MEMORANDUM

**SUBJECT:** Response to comments by OEHHA on DPR-HHAB’s draft 1,3-dichloropropene risk assessment document (dated August 31, 2015)

**Responses to OEHHA comments on HHAB’s draft 1,3-dichloropropene RCD (dated Aug. 31, 2015)**

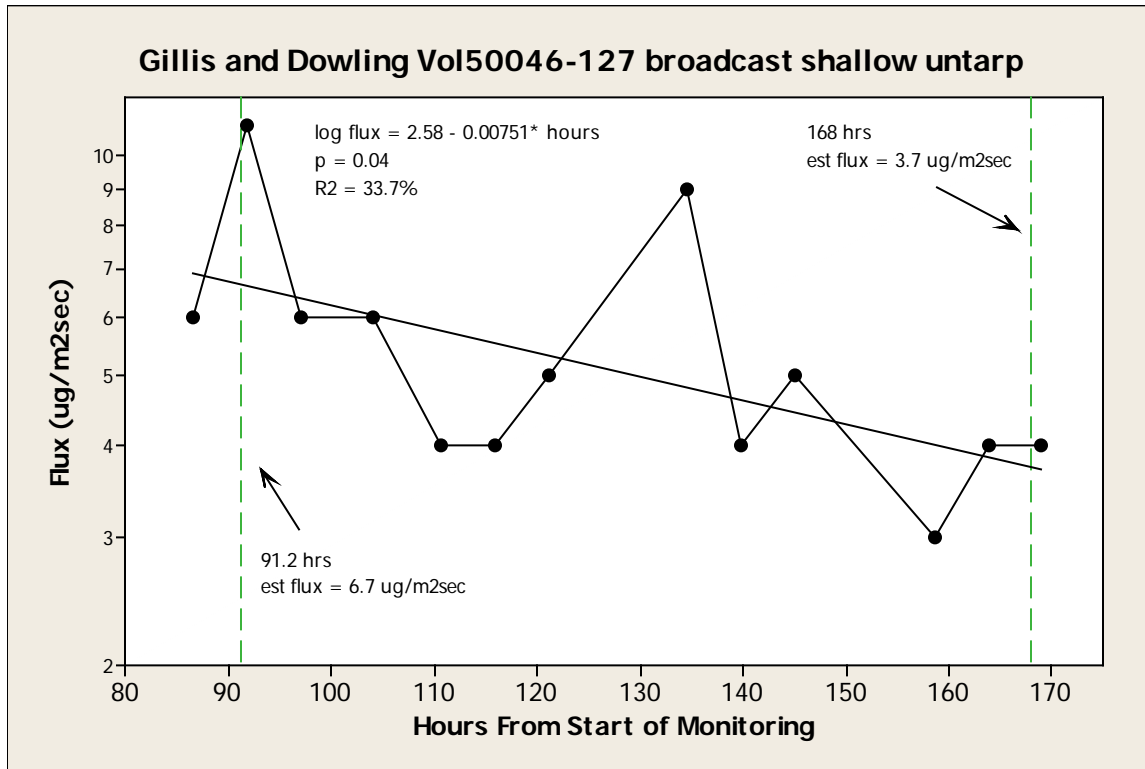
**OEHHA comment #8 (page 22):** OEHHA recommends that DPR (1) clarify why some activities can take place before the end of the REI and (2) estimate the uncertainty in using a study conducted 3.8 days post-fumigation as representative of all reentry activities.

The general pattern of the flux profile is exponential decline after the first peaks are reached at 15 and 37 hrs. However, it is clear that fitting that exponential would be difficult to impossible. TableCurve® software was used to fit the decline and, as expected, no acceptable fit could be found. There is a decline but fitting a single viable function is impossible. The interval between 3.8 days (91.2 hrs) and 7 days (168 hrs) is shown as vertical lines. It is clear that the flux values in this interval are not monotonically decreasing. However, it appears it is likely that the flux at 91.2 hrs is numerically larger than the flux at 168 hrs. This does not mean the flux between those two time points are statistically different.

Flux is only one of the variables that produce air concentrations to which workers will be exposed. Although it is true that in air dispersion modeling that air concentrations are directly proportional to flux, that is *with all other factors held constant*. So, the uncertainty in differences in meteorology between these two time points should be considered. In addition, if the air concentrations associated with these flux values were modeled using an air dispersion model, it should be noted that air dispersion models are considered to generally produce air concentrations within a factor of 2 of the actual air concentrations generated by that flux.

Regression analysis of the portion of the entire flux profile that falls between 86.6 hrs and 168 hrs is shown below. The regression is statistically significant, showing  $p = 0.04$  for the slope. The  $R^2 = 33.7\%$ . While the regression is statistically significant it is clear that the linear function fits poorly. The estimated fluxes are  $6.7 \text{ ug/m}^2\text{sec}$  and  $3.7 \text{ ug/m}^2\text{sec}$  for 91.2 hrs and 168 hrs, respectively. The ratio of 3.7 to 6.6 is 0.55. So, the flux at 91.2 hrs is slightly less than double the flux at 168 hrs.

In summary, uncertainty is created by the lack of a monotonically decreasing flux profile in the area of interest (91.2 hrs to 168 hrs), the resulting poor fit of the regression, and the air dispersion model factor of two acceptability. Another potential source of uncertainty is the analytical variability of the study.
